UNITED STATES PATENT AND TRADEMARK OFFICE

| APPLICATION NO. | FILING DATE | FIRST NAMED INVENTOR | ATTORNEY DOCKET NO. | CONFIRMATION NO. |
|-----------------|-------------|----------------------|---------------------|------------------|
| 10/761,955 | 01/21/2004 | Nobuo Yamazaki | S011-5192 | 3878 |

| Office Action Summary | Application No. 10/761,955 | Applicant(s) YAMAZAKI ET AL. | |

- 1) ☒ Responsive to communication(s) filed on 16 December 2005.
- 2a) ☒ This action is **FINAL**. 2b) ☐ This action is non-final.
- 3) ☐ Since this application is in condition for allowance except for formal matters, prosecution as to the merits is closed in accordance with the practice under *Ex parte Quayle*, 1935 C.D. 11, 453 O.G. 213.

FIG. 5

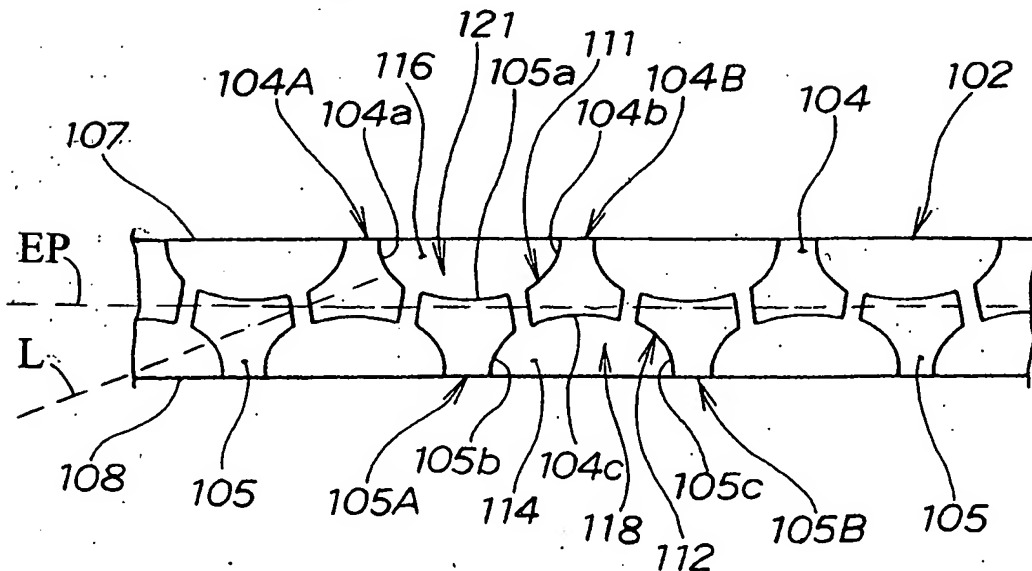
4) In view of the above new matter rejections, the proposed drawing correction for figure 5 has not been approved by the examiner (the selection of line L for defining the symmetry of the depressed portions being new matter).

Am 3-5-06
NOT APPROVED
